SIGAR 20-45 Inspection Report

**Afghan Ministry of Interior Security Upgrades:
Project Was Generally Completed According to
Contract Requirements, But Construction and
Maintenance Problems Exist**

**JULY
2020**

Photo 7 - Example of Padlocked Exit Door

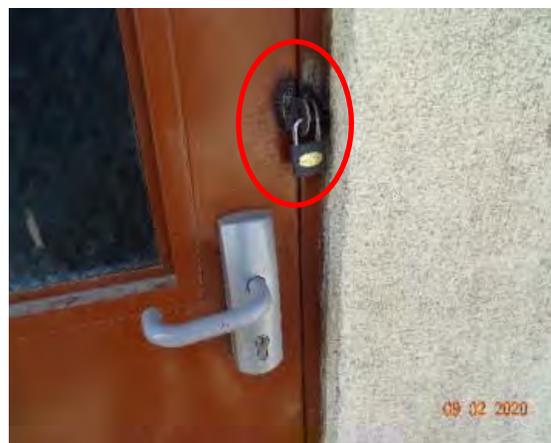
During our February 9, 2020, site visit, we found that two of the ECP building's seven exit doors were missing panic bars, which can be pushed to quickly leave the building in a fire or other emergency (see photo 6). Additionally, the MOI installed padlocks on the outside of five of the doors (see photo 7), which could trap occupants inside during an emergency.¹⁰ The MOI's changes to the approved and installed door hardware on the building exit doors creates serious safety hazards for ministry staff and visitors.

Photo 8 - Interior of Damaged Guard Shack

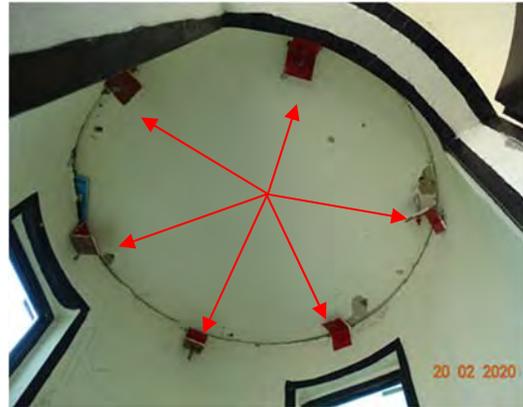
During our February 5, 2020, site visit, we found that the roof of a guard shack was separated from its structure. This happened when the MOI moved the shack from its original location outside the parking lot entry checkpoint to its current location inside the lot. All six angle brackets securing the roof to the walls became detached (see photo 8). Although the roof was still in position, the damage could result in a roof that leaks. It also presents a safety hazard if the MOI decides to move the structure again and the unsecured roof becomes completely detached.
